**BLUE BIRD**

**SUBJECT: RECALL R10SL STARTER CABLE AND ENGINE WIRING  
HARNES MAY CONTACT FAN HUB**

R10SL

# Starter Cable and Wiring Harness May Contact Engine Fan Hub

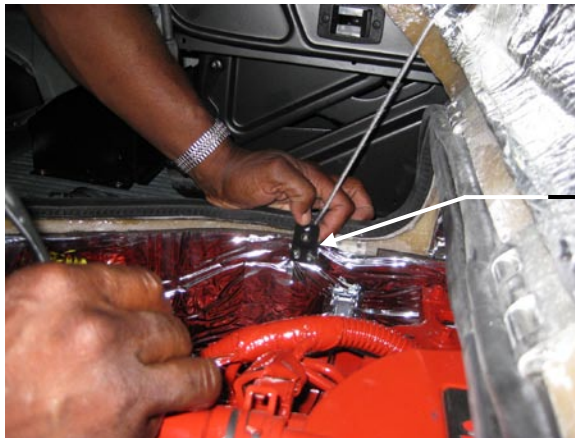
The ¼” serrated flange head nuts that secures the starter cable and engine wiring harness to the mounting brackets located on the front of the engine may become loose and fall off allowing the cable and harness to contact engine fan drive belt or the fan clutch assembly.

Replace ¼” serrated head flange nut with a ¼” locking nut, add a flat washer and inspect starter cable and engine wiring harness.

Area of Right side support Bracket, See photo in Step 7

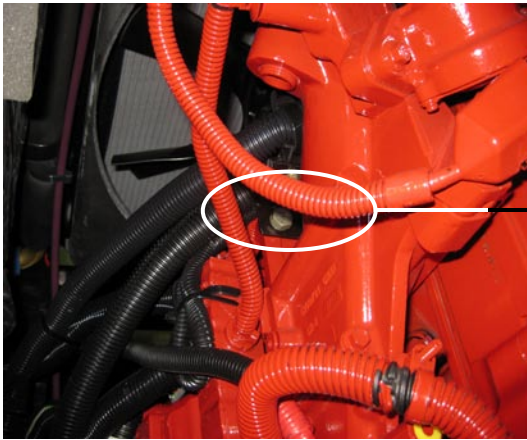
- 6 One starter cable and wiring harness support is located on the right side of the engine between the alternator and engine fan.
- 7 Remove and discard the ¼" serrated nut (and flat washer if installed). Install the new ¼" locknut (0145847) and flat washer (01247709) provided. Torque nut to 60-85 in. lbs. Note: two complete threads must extend completely through the nut.

Replace with new locknut and flat washer (Note: new locknut shown)

Left Side support

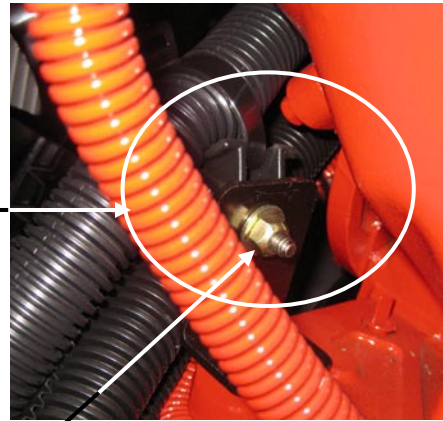
8. The second starter cable and wiring harness support is located on the front left side of the engine block.
9. Remove and discard the  $\frac{1}{4}$ " serrated nut (and flat washer if installed). Install the new  $\frac{1}{4}$ " locknut (0145847) and flat washer (01247709) provided. Torque nut to 60-85 in. lbs. Note: two complete threads must extend completely through the nut.

Replace with new locknut and flat washer (Note: New locknut shown)

Area of Right Side Support Bracket, see photo in step 5

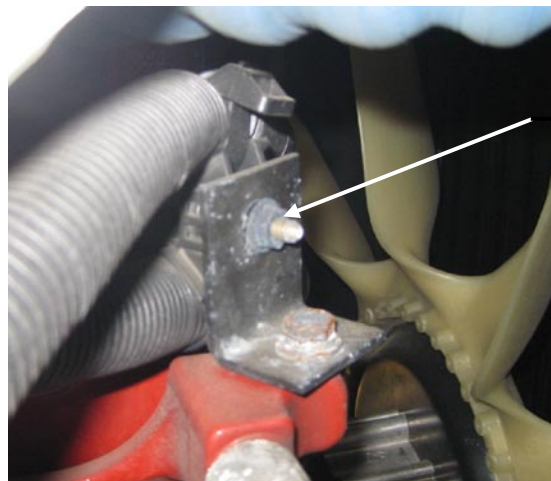
- 4 One starter cable and wiring harness support is located on the right side of the engine between the alternator and engine fan.
5. Remove and discard the ¼" serrated nut (and flat washer if installed). Install the new ¼" locknut (0145847) and flat washer (01247709) provided. Torque nut to 60-85 in. lbs. Note: two complete threads must extend completely through the nut.

Replace serrated nut (shown) with new locknut and flat washer

Left Side Support

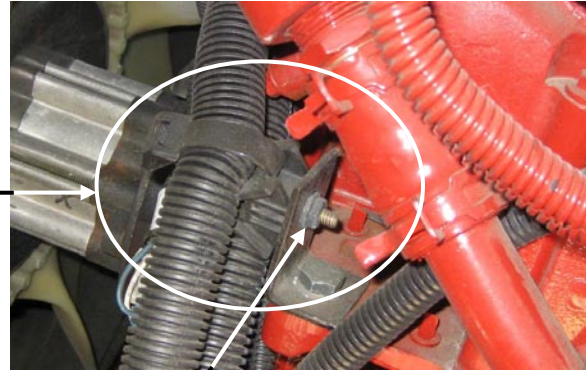
Replace serrated nut (shown) with locknut and flat washer

- 7 Remove and discard the 1/4" serrated nut (and flat washer if installed). Install the new 1/4" locknut (0145847) and flat washer (01247709) provided. Torque nut to 60-85 in. lbs. Note: two complete threads must extend completely through the nut.
  8. Reinstall the engine cover assembly by reversing the steps above. Reconnect the batteries.
- Caution:** *When reconnecting the batteries, connect the negative cable last.*
9. Place bus back in service.
